Revision of Manuscript Number: IEEE-TPWRS-01391-2021, version 1 March 9, 2022
Journal: IEEE Transactions on Power Systems
Author: Abhishek Halder, Kenneth F. Caluya, Pegah Ojaghi, Xinbo Geng

Response to decision:

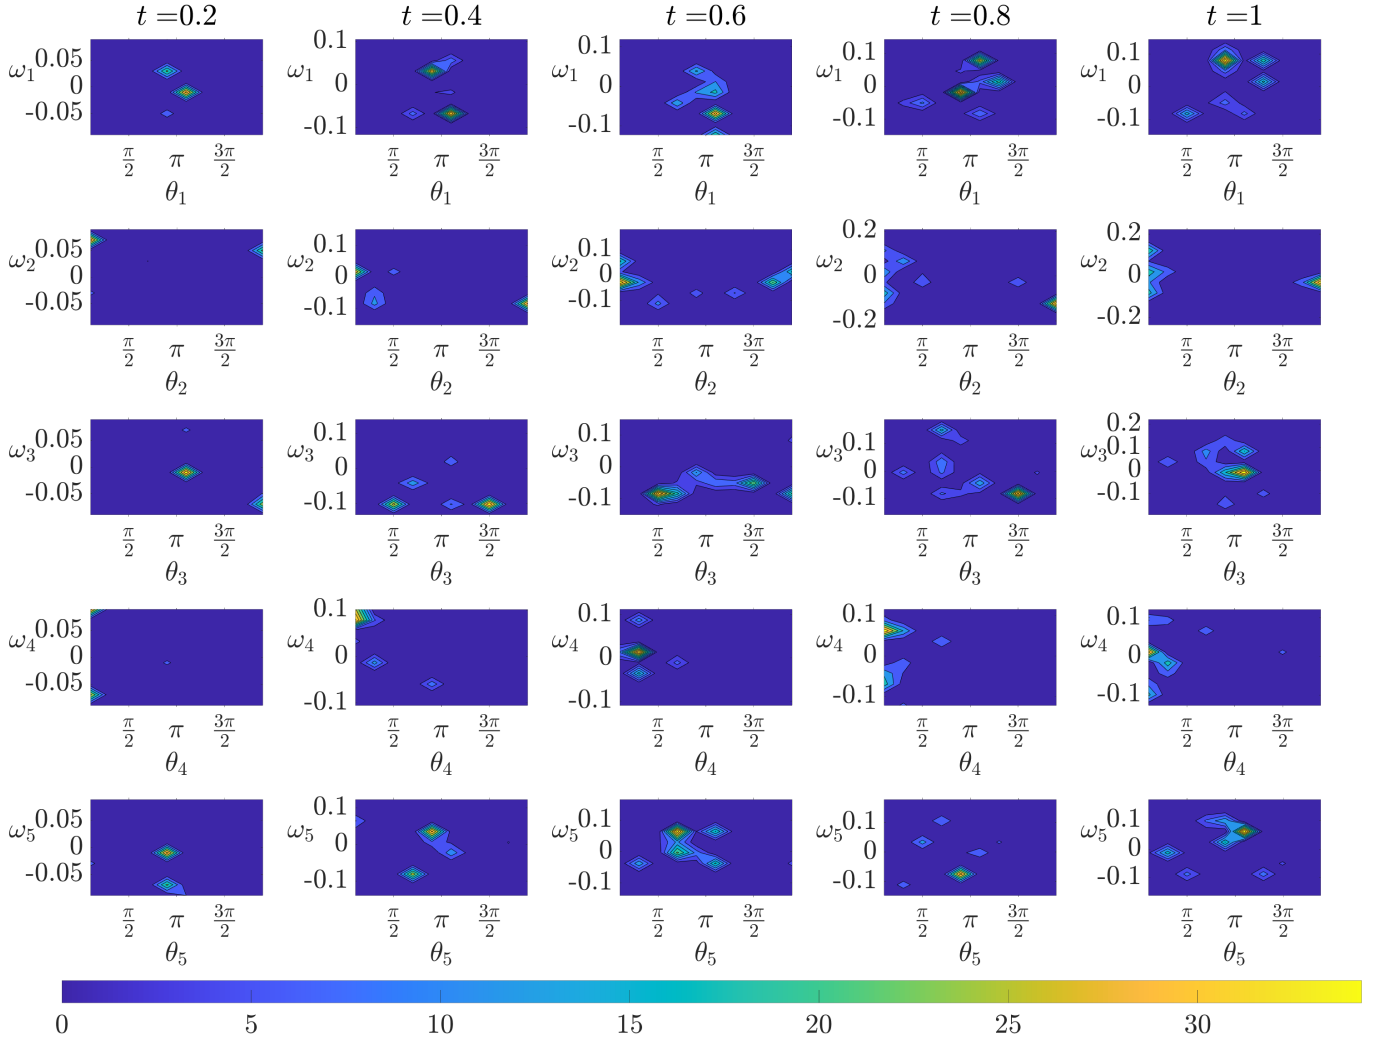
Figures 5 and 6 are unreadable.

Response: Thanks for this comment. In the previous version, the strict 10 page limit enforced small figure sizes. In the revised manuscript, Figures 5 and 6 are made larger. Also, the Fig. 6 in the revised manuscript shows the transient (θ_i, ω_i) bivariate marginals for all the five generators in Case II; the previous version showed the same only for the generator 4 (bus 6). We believe these changes have improved clarity.

Regarding the style of plots, we had considered plotting the bivariate marginals as planar contour plots (as in Fig. 1 in this rebuttal document) but decided against it because of the following two reasons.

First, this kind of plot is scientifically misleading as they hide the fact that these bivariate marginal PDFs are not really supported on the plane, or the subsets thereof, but instead have cylindrical supports. Our message that the proposed method explicitly accounts this manifold geometry in the computation, would be missed had we chosen to make the plots the other way.

Second, the planar contour marginal plots require additional mental efforts from the readers to correctly parse the statistical information conveyed. For instance, consider the fourth column, second row subplot in Fig. 1 in this rebuttal document. It is upon the reader to parse that the two high probability regions on the left and right of that subplot are actually referring to the same angular high probability region around $\theta_2 = 0$ rad, thanks to the periodic boundary condition on the angular variable. We thus prefer to make plots that depict the variables as they are.
